Addendum Number 3

Lake Peachtree Spillway Replacement Project

August 4, 2017

PROJECT:	16C17043.00
DATE:	07/10/2017
SHEET	52 OF 66
DATE	
<i>Randall P. Bass</i> GEORGIA PROFESSIONAL ENGINEER NO. 10885 REV. 07/10/17	
 Schnabel ENGINEERING 6445 Shiloh Road, Suite A / Alpharetta, GA 30005 / Phone: 770-781-3003 / Fax: 770-781-3003 / Schnabeleng.com	
DESCRIPTION

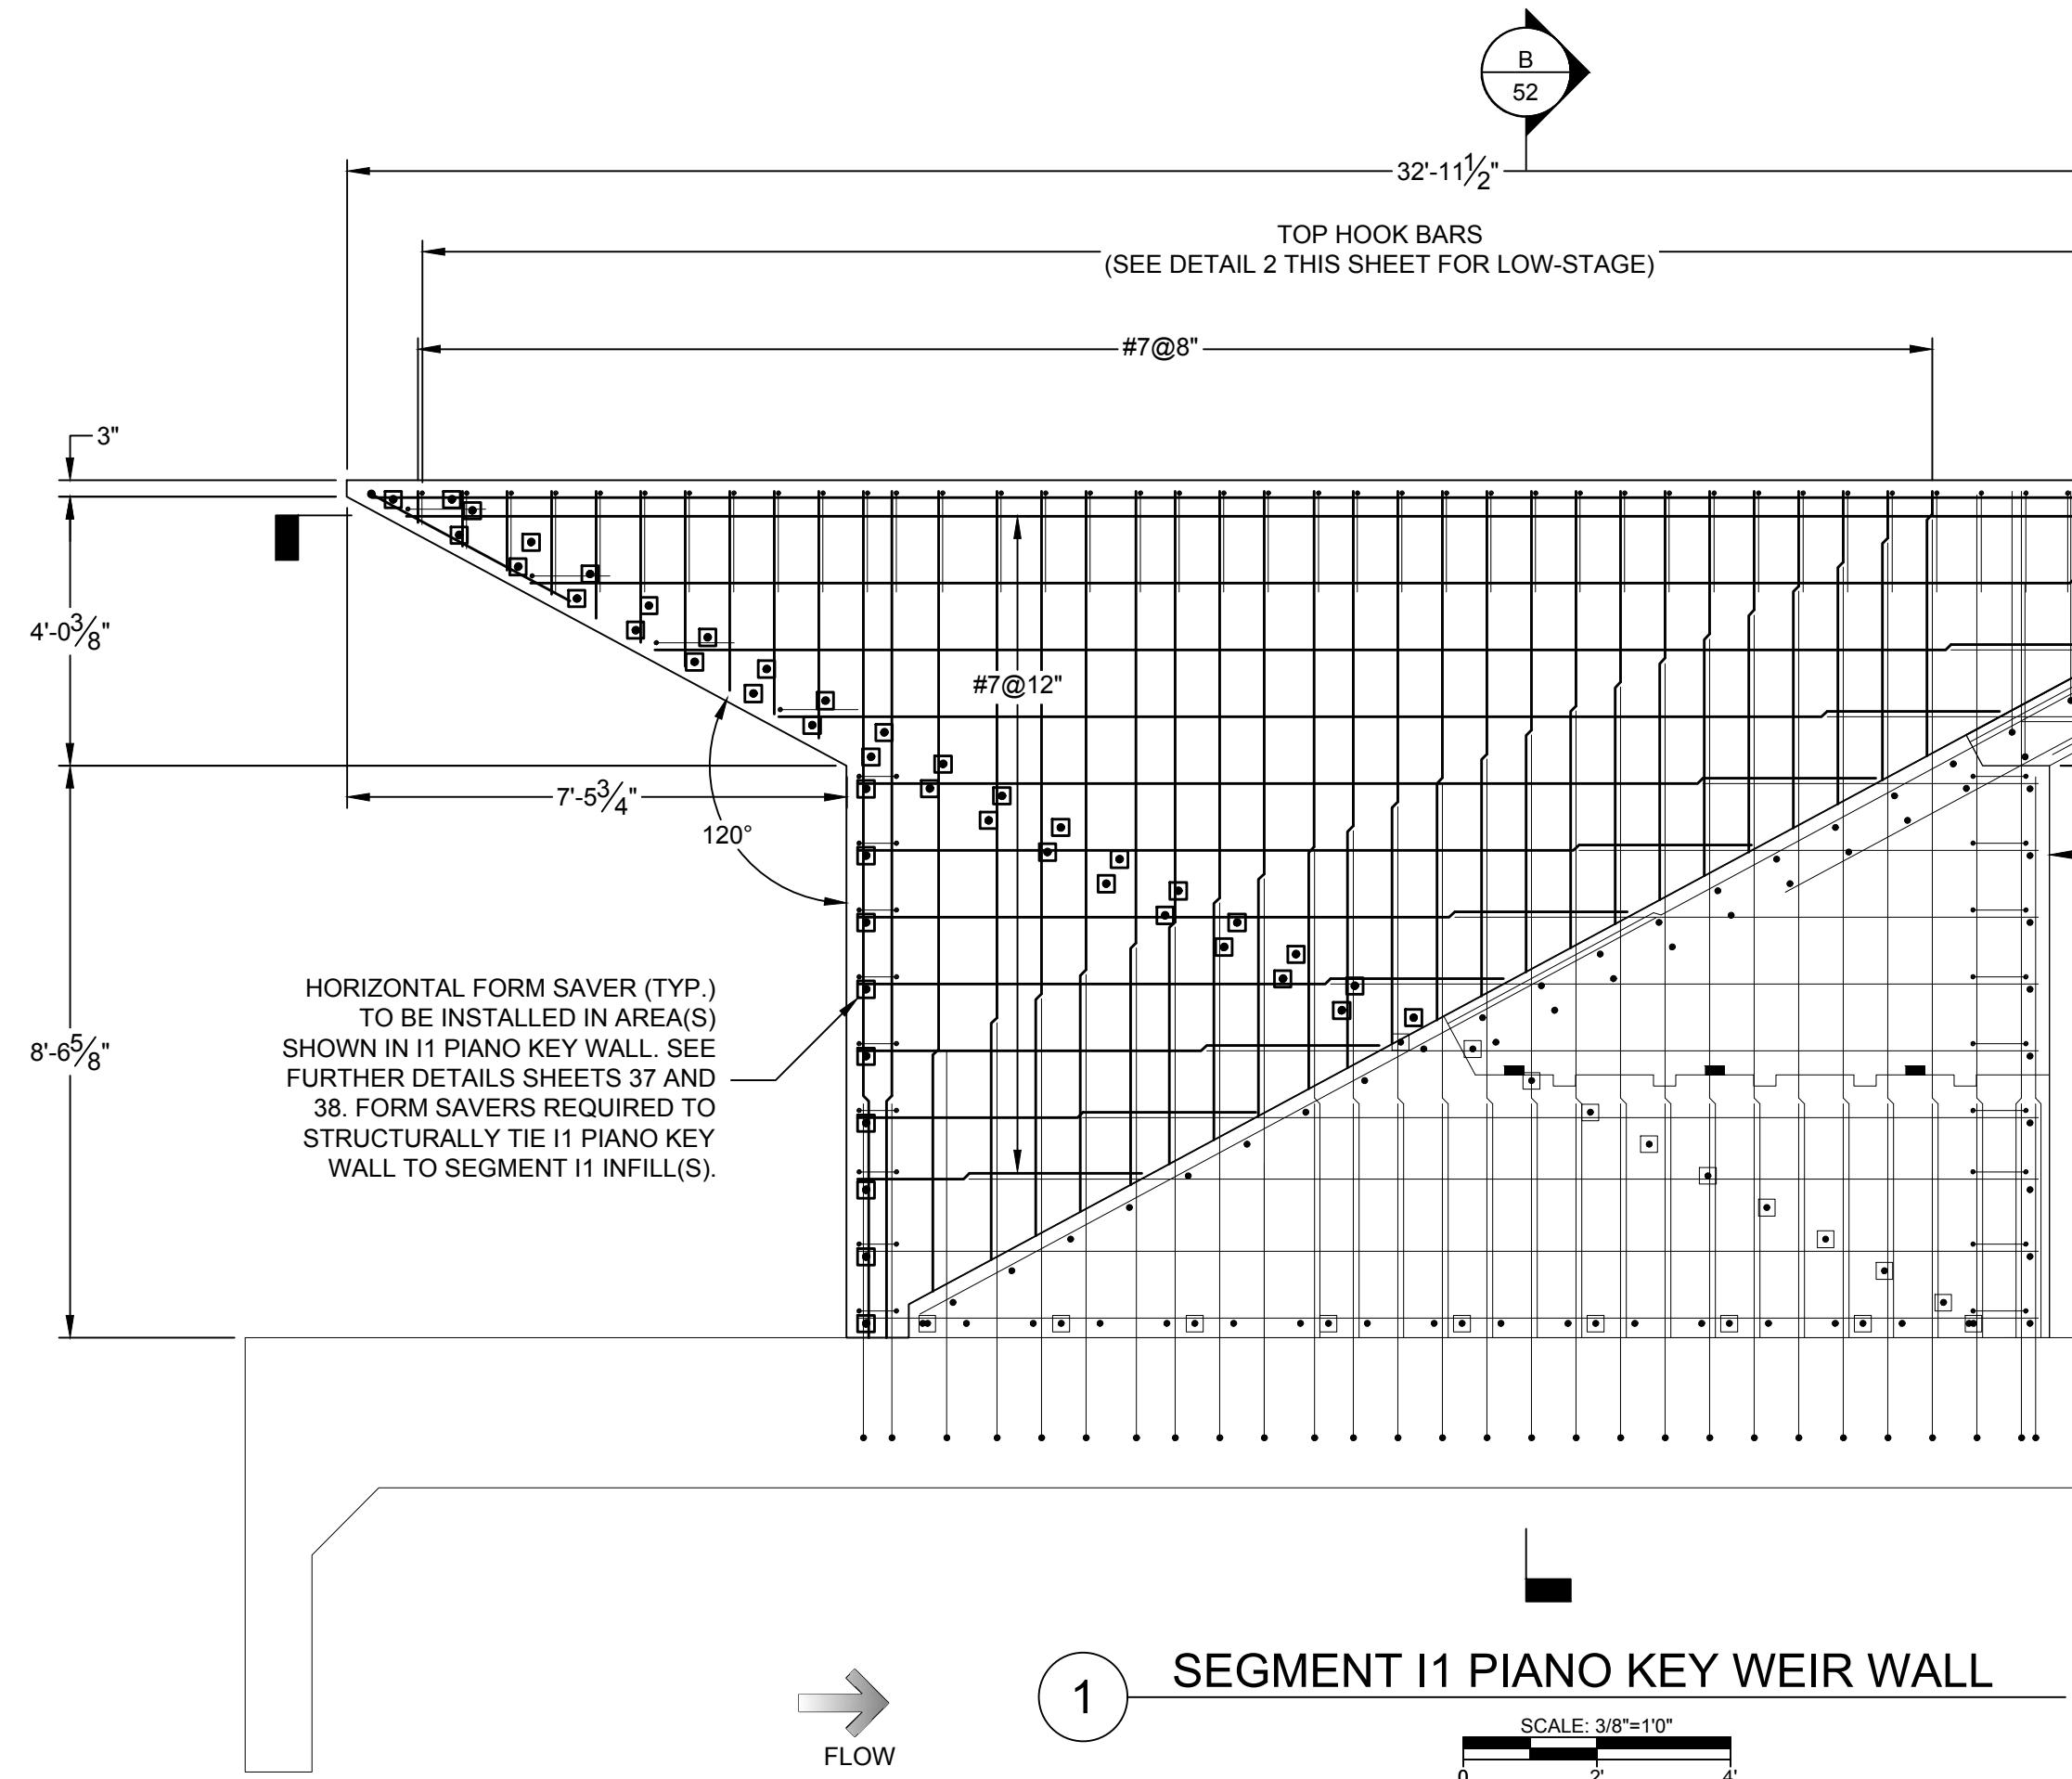
Note: Additional temperature and shrinkage reinforcing steel was added in the ramp/infill sections of the piano key weirs. Sheets with material changes were noted as Revised per Addendum No. 3. Sheets that were inadvertently affected by the changes are included, but do not contain revision clouds/call-outs. The additional reinforcing typically includes the addition of #5@12" spacing, #7@12" spacing, and #4@24" spacing depending on the specific locations of reinforcing.
